Name of proposed development	Y Bryn Wind Farm
------------------------------	------------------

A3.3.65 NRW EMAIL RESPONSE TO CHARGED PRE-APPLICATION ADVICE REQUEST – OCTOBER 2022

A3.3.66 NRW RESPONSE TO CHARGED PRE-APPLICATION ADVICE REQUEST – OCTOBER 2022

A3.3.67 NPTCBC PRE-APPLICATION ADVICE RESPONSE TO NP –NPTCBC – JANUARY 2023

Figure A3.3.5: Design freeze layout for Y Bryn Wind Farm

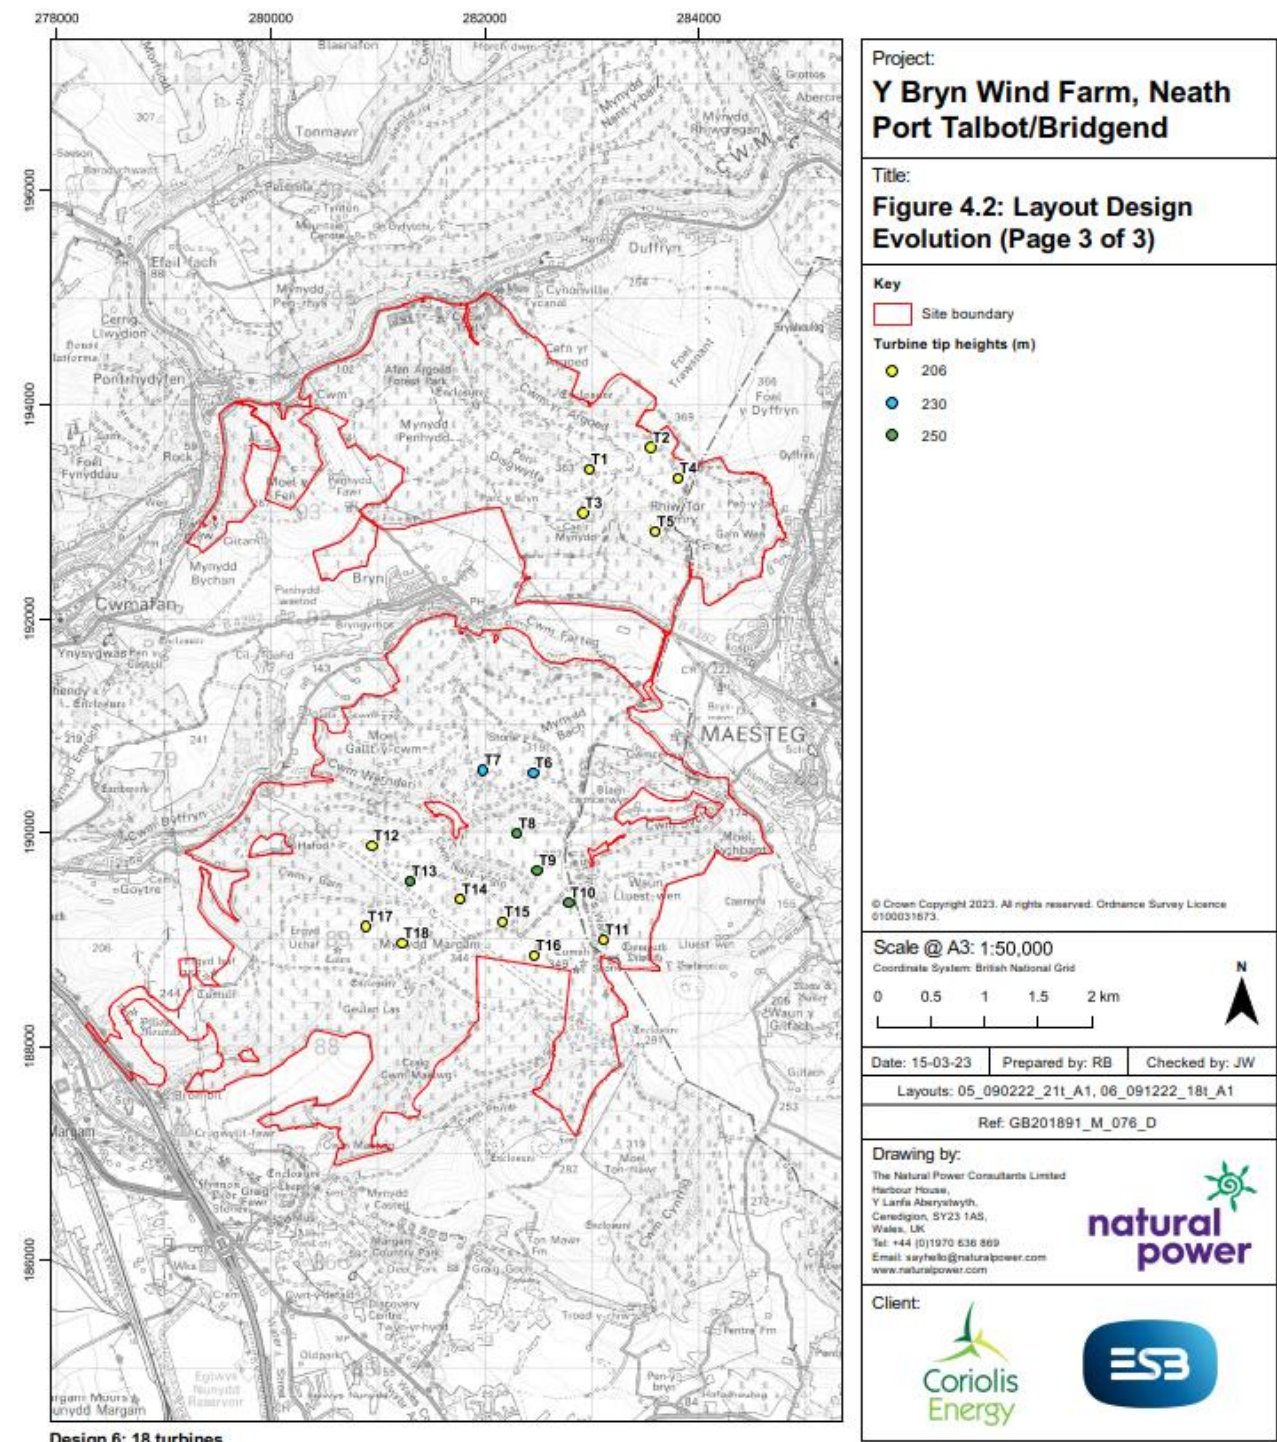
Consider reference to estimated height and annual growth rates in relation to age. For example, in relation to T7 and T8 the text says that the young crops will duplicate the screening of the two felled coupes harvested in 2027, it would be prudent to note the height of the young crops now in relation to the crop to be harvested as seen in the view and whether they grow sufficiently to replace the screening by 2027. Similarly, the statement that the replanting of the two closer felled areas would provide screening from 2031 onwards i.e., after 5 years growth.

The northern section text states that the coupes planted in 2004 and 2014 will grow and reimpose a degree of screening as current to T4 and the Minimal Intervention and LISS coupes will also contribute to the screening of T4, and T6. Should this refer to T4 and T1?

T5 and T6 are also fronted by an orange Clearfell 2027-31 area so confirmation should be provided on whether the young crops around the turbines provide the same degree of screening by 2027 as the felled crop do now.

We would advise a hatched outline to the turbines to show that they are behind the tree screen, not in front e.g., T7 and T8 and a solid line where they are visible above the tree line.
